SUBJECT: Forwards addl info re second 10-yr inservice insp summary plan per 840817 request.

Re: Turkey Point Units 3 and 4
Docket Nos. 50-250, 50-251
Inservice Inspection
Second 10-year Summary Program

FIRST & SECOND INTERVAL RELIEF REQUESTS

INSERVICE INSPECTION

FIGURE NO. 2

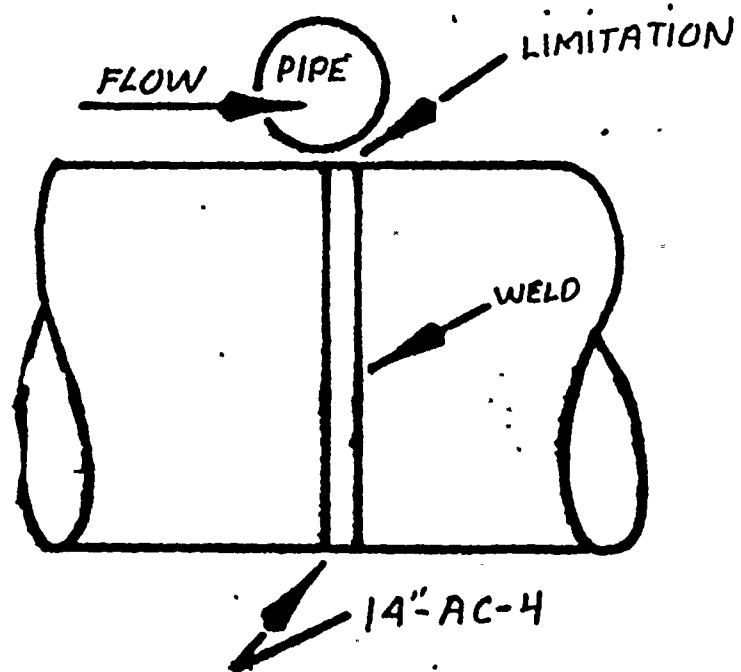
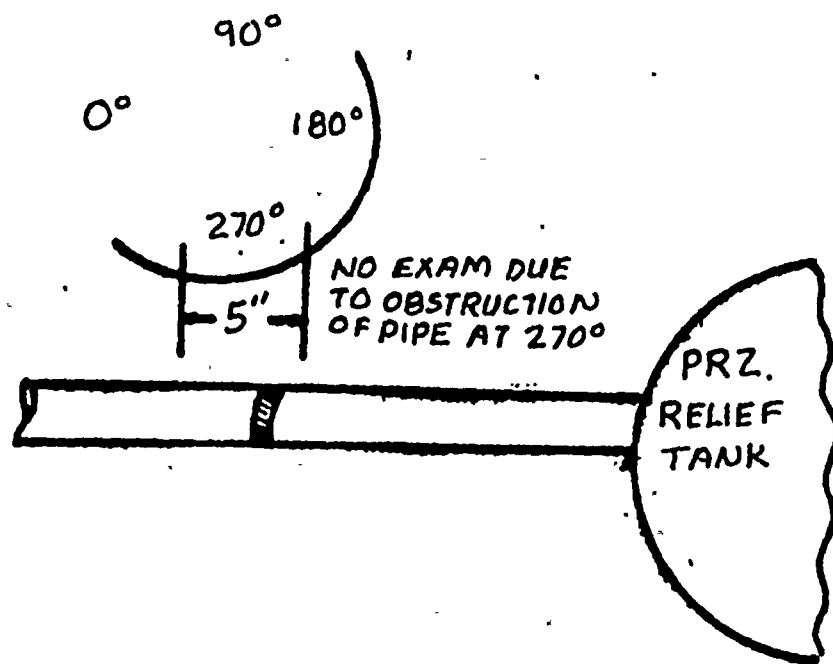
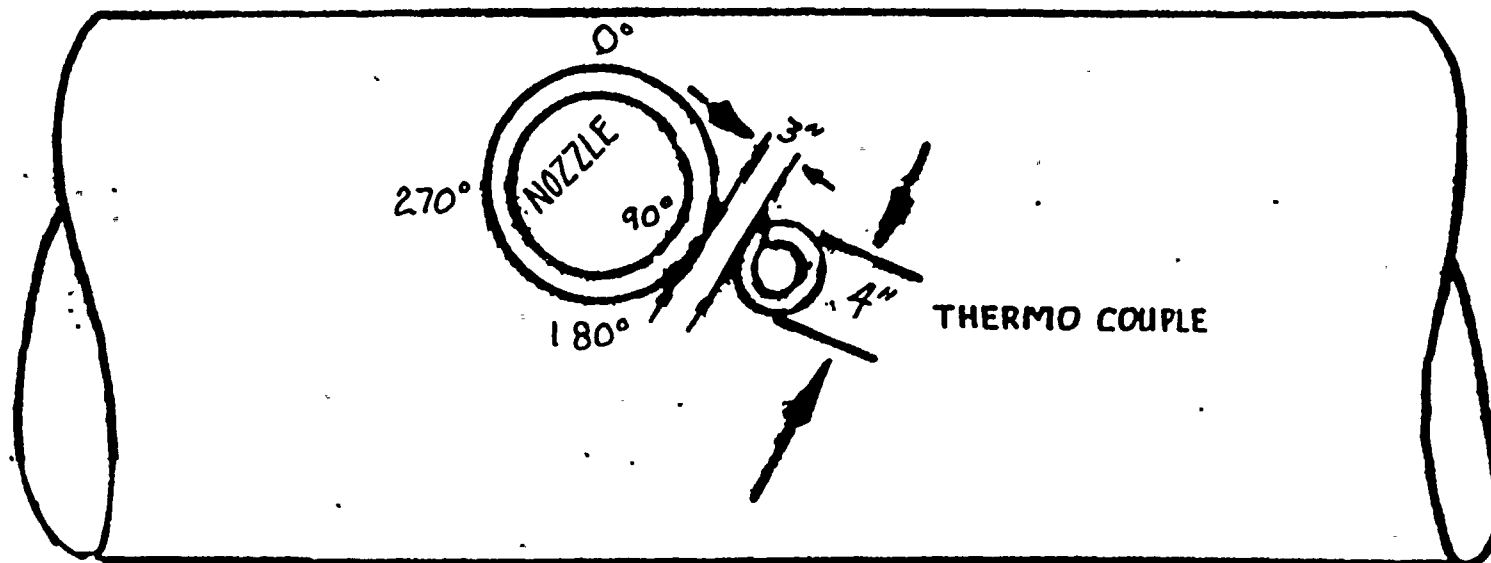
Item B4.5	(12"-RC-3)	6" of circumferential weld	FIG. NO. 1
Item B4.5	(14"-AC-4)	5" of circumferential weld	FIG. NO. 2
Item B4.6	(12"/10"-RC)	An area 4" x 3" of circ. weld	FIG. NO. 3

Fig. no. 2 Limitation due to proximity of adjacent pipe run
at 270 degrees.

- 1) Periodic System Leakage tests per category B-P, Table IWB-2500.
- 2) Inservice hydrostatic test per category B-P, Table IWB-2500.

FIGURE NO. 3

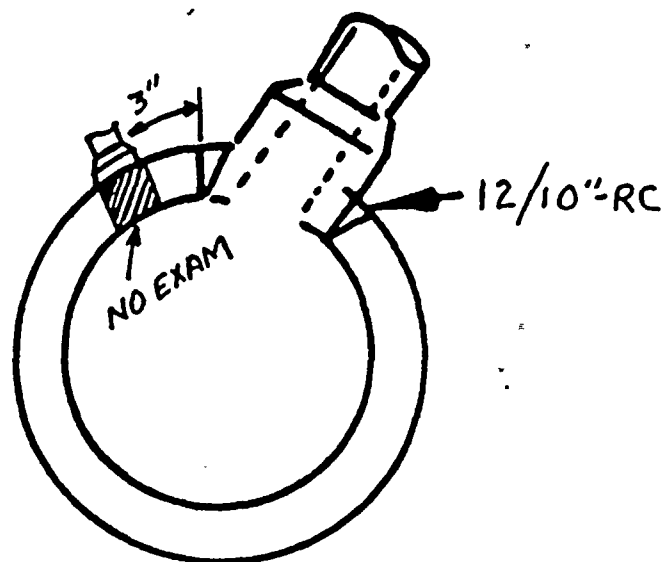
Fig. no. 3 Limitation due to the location of thermocouple at 100 degrees.

A 3"x4" AREA CAN NOT BE SCANNED DUE
TO THERMO COUPLE

FIGURE NO. 1

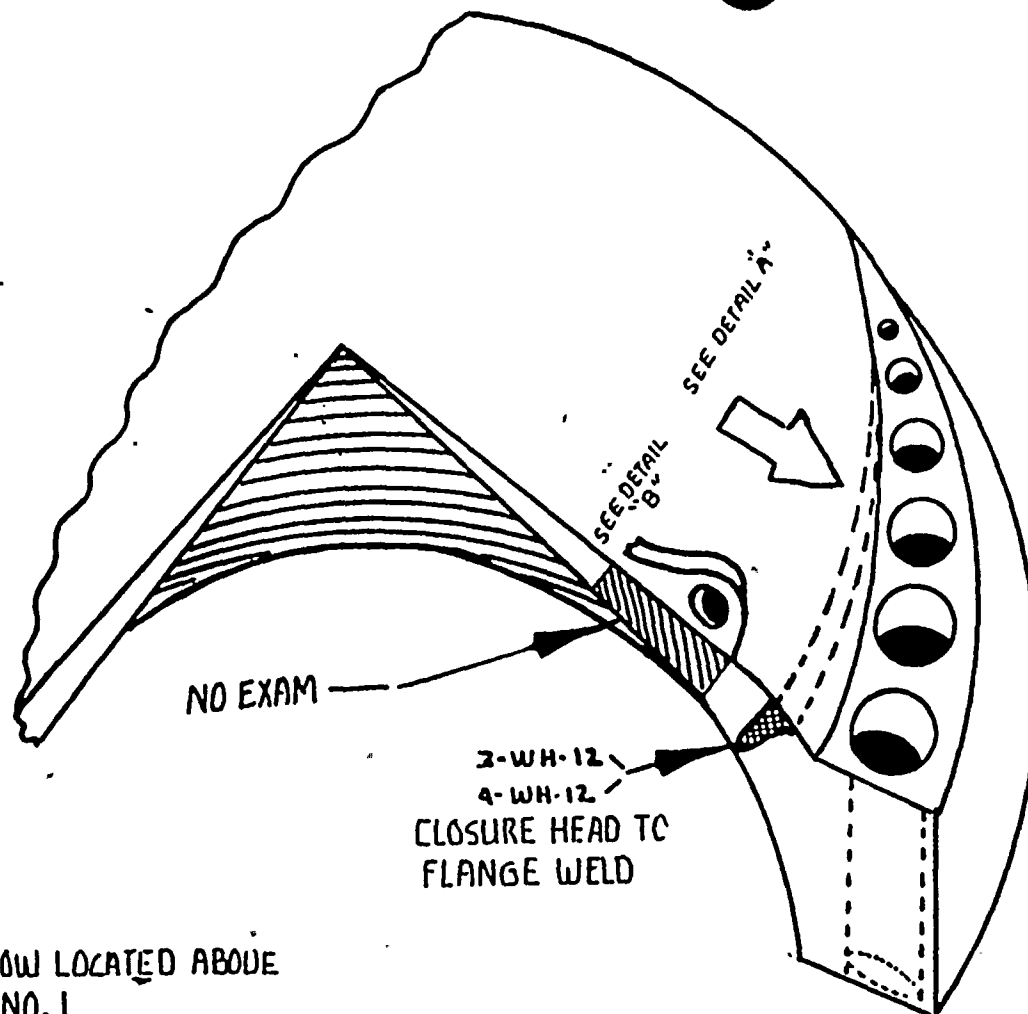
Figure No. 1 Limitations due to welded arrow located above stud hole No. 1. The arrow limits 7" of circumferential scanning of the closure head weld.

- 1) Periodic System Leakage tests per category B-P, Table IWB-2500.
- 2) Inservice Hydrostatic test per category B-P, Table IWB-2500.

DATE: 5-30-84	DRAWN BY: E L ANDERSON	APPROVED BY:
SCALE: NONE	REVISED:	
RPV CLOSURE HEAD WELDED ATTACHMENT LOCATIONS		
RELIEF REQUEST NO. 14		DRAWING NUMBER: FIGURE NO. 2

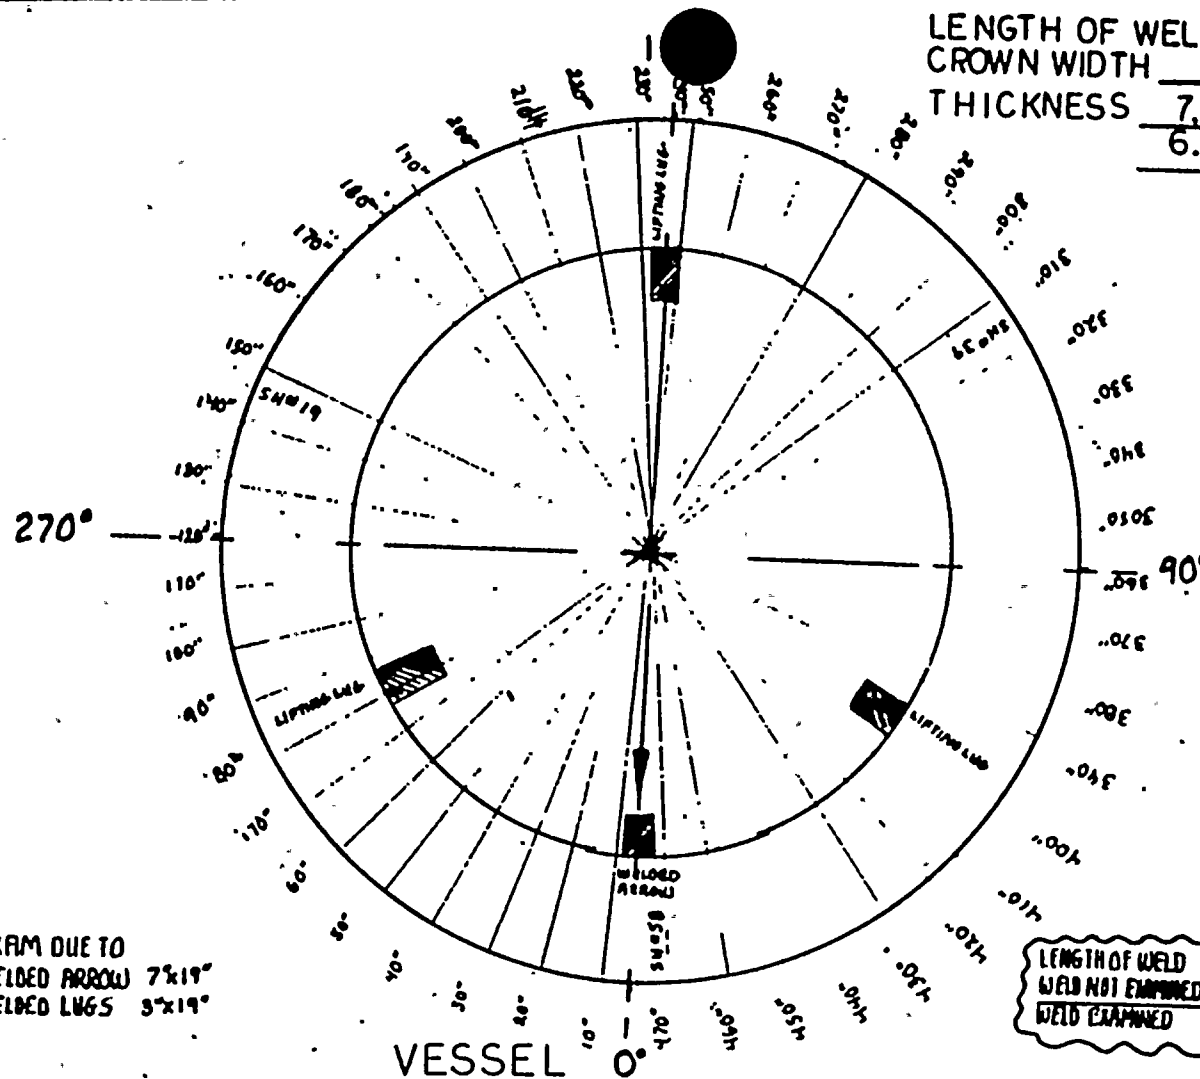
Figure No. 2 Limitations due to 3 welded lugs located 120 degrees apart, between stud holes 10/11, 29/30 and 48/49. Each lug limits 3" of circumferential scanning of the closure head.

NO EXAM DUE TO
 1. WELDED ARROW 7x19"
 2. WELDED LUGS 3x19"

TURKEY POINT UNITS 4		
DATE: 5-29-84	DRAWN BY: E.L. ANDERSON	APPROVED BY:
SCALE: NONE	REVISED:	
RPV SHELL TO FLANGE WELD		4-WR-18
RELIEF REQUEST NO. 15		FIGURE NO. 2

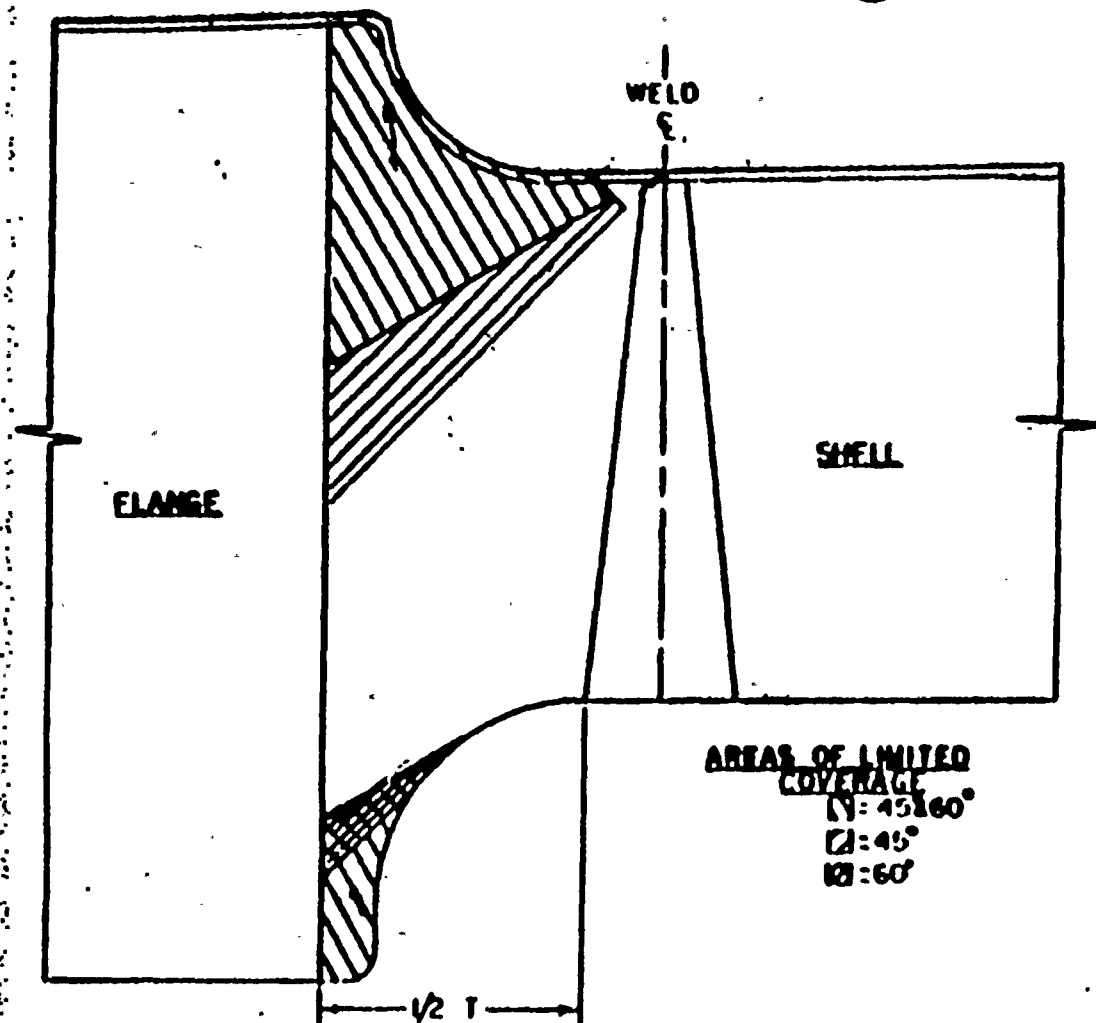
2.1 The areas receiving no coverage during the examination performed from the upper shell side are depicted in Figure No. 2.

TURKEY POINT UNITS 4		
DATE: 5-29-84	DRAWN BY: F.L. ANDERSON	APPROVED BY:
SCALE: NONE	REVISED:	
RPV SHELL TO FLANGE WELD		4-WR-18
RELIEF REQUEST NO 15		DRAWING NUMBER FIGURE NO. 3

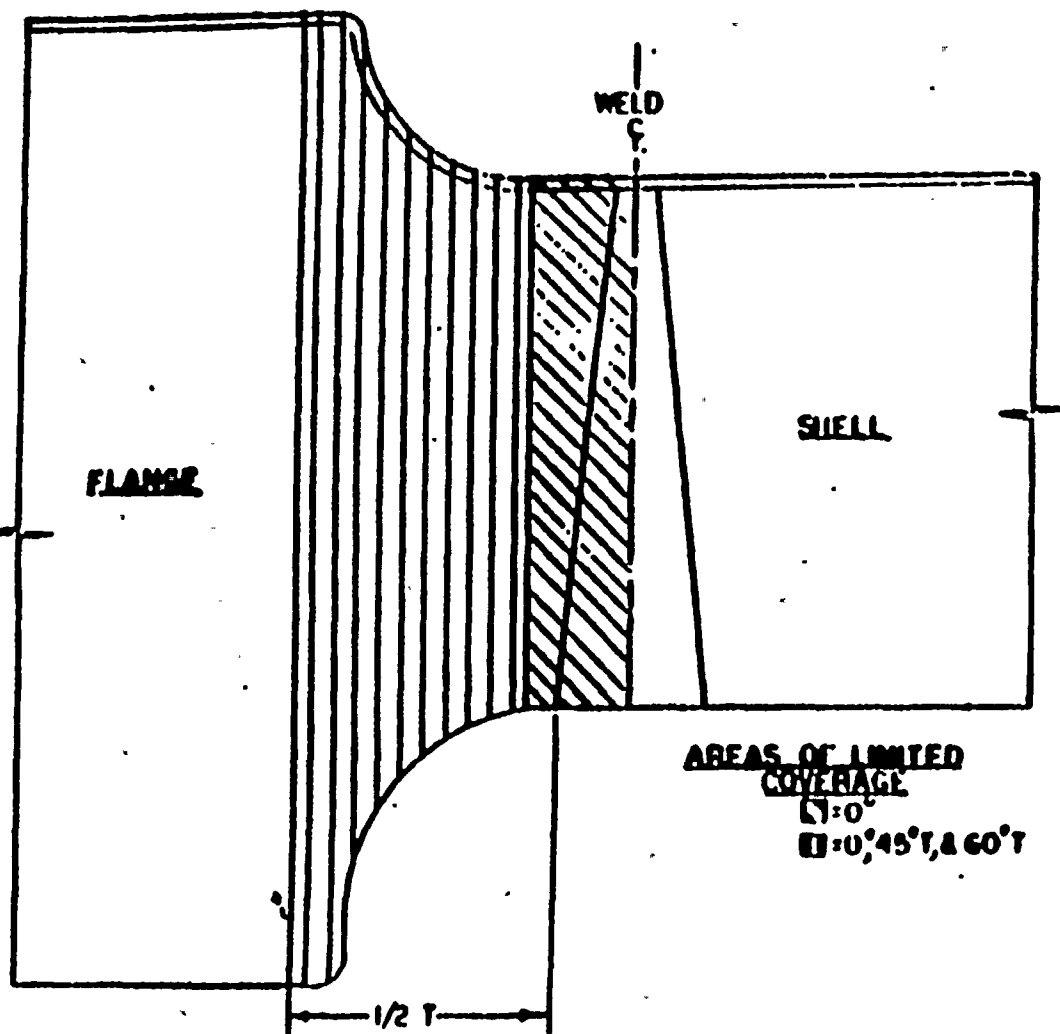
2.2 Figure No. 3 depicts those areas that did not receive 0 degree, 45 degree transverse or 60 degree transverse weld coverage due to the geometric configuration of the flange radius located just above the weld. Percent of coverage limitation is contained in Table 1.

FIGURE NO. 2

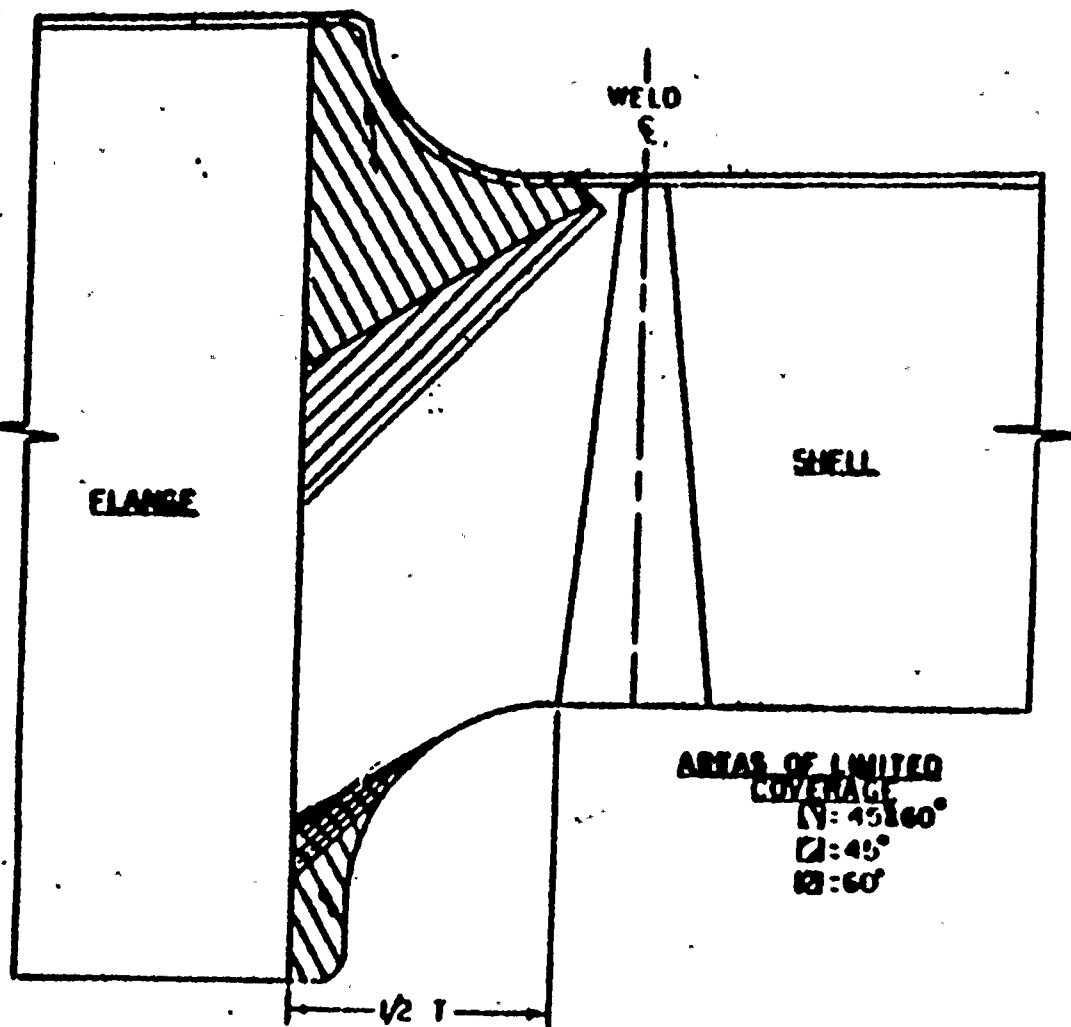
2.1 The areas receiving no coverage during the examination performed from the upper shell side are depicted in Figure No. 2.

FIGURE NO. 3

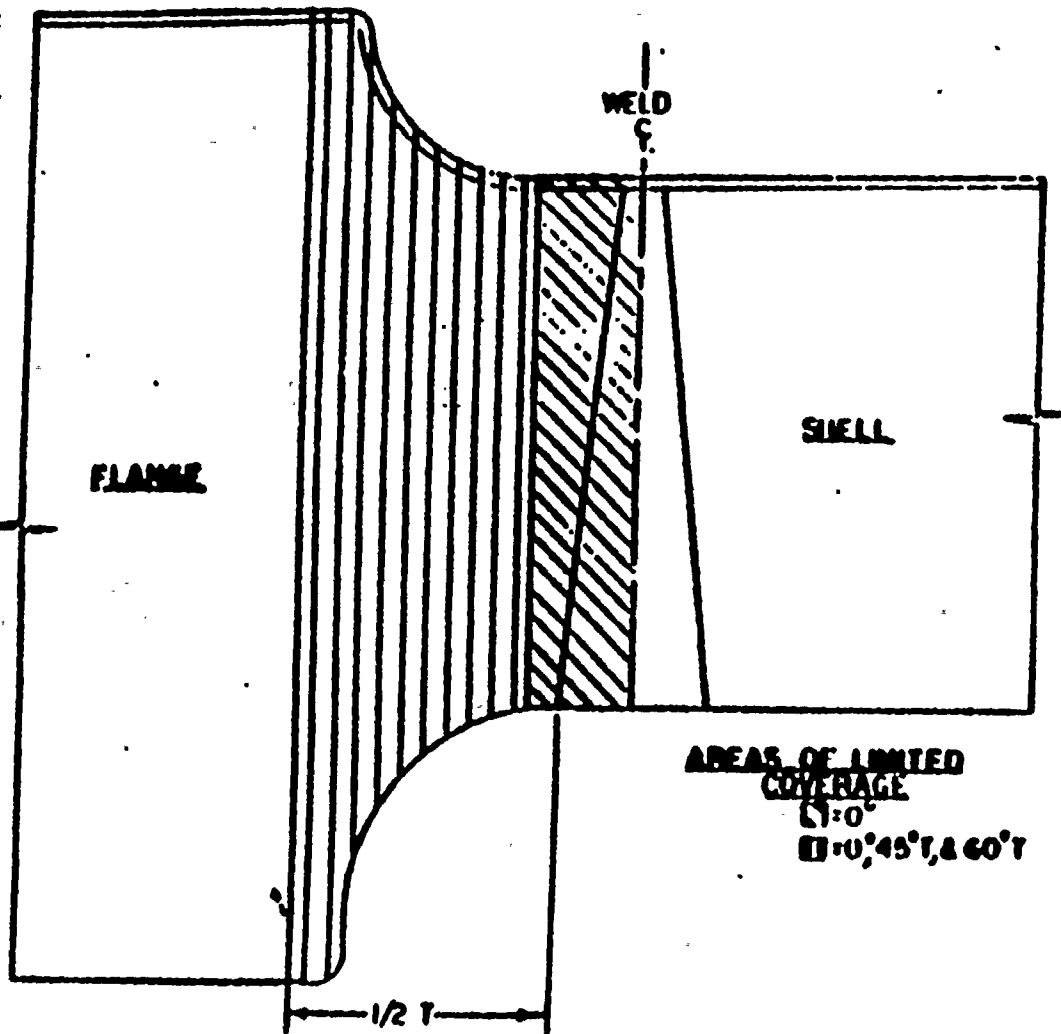
2.2 Figure No. 3 depicts those areas that did not receive 0 degree, 45 degree transverse or 60 degree transverse weld coverage due to the geometric configuration of the flange radius located just above the weld. Percent of coverage limitation is contained in Table 1.

FIGURE NO. 1

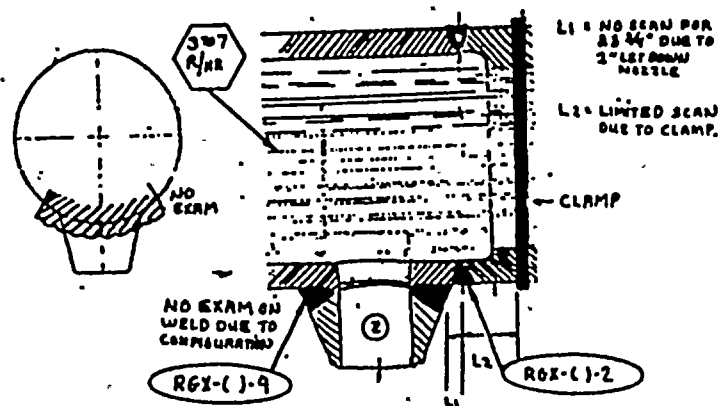
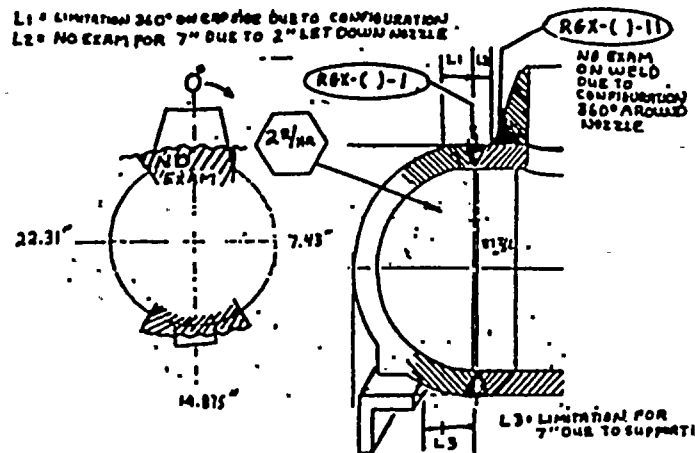
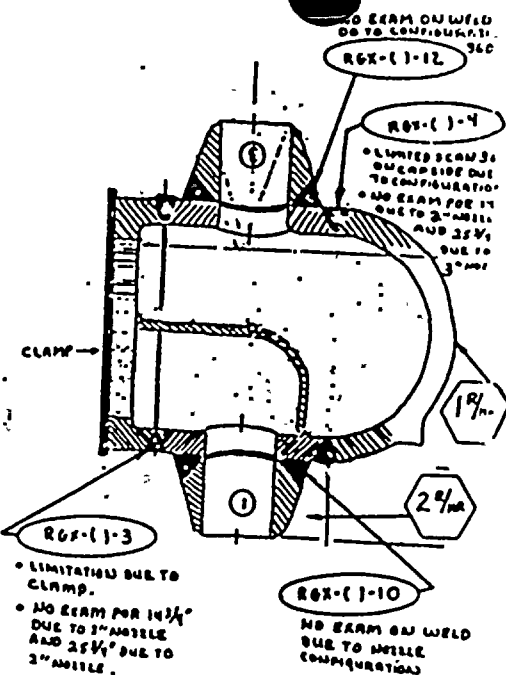
- Florida Power & Light Company performed examinations on both Units 3 & 4 heat exchangers during the first and second inspection periods. The coverage and/or the examination limitations are depicted in figure no. 1.(The RGX examination coverage and/or examination limitations.) The regenerative heat exchanger component design arrangement and accessibility are not normally conducive to meaningful examination.(see fig. no. 2 for design configuration)

L1 = LIMITATION 360° ON EXPOSED DUE TO CONFIGURATION
L2 = NO EXAM FOR 7" DUE TO 2" LET DOWN ANGLE
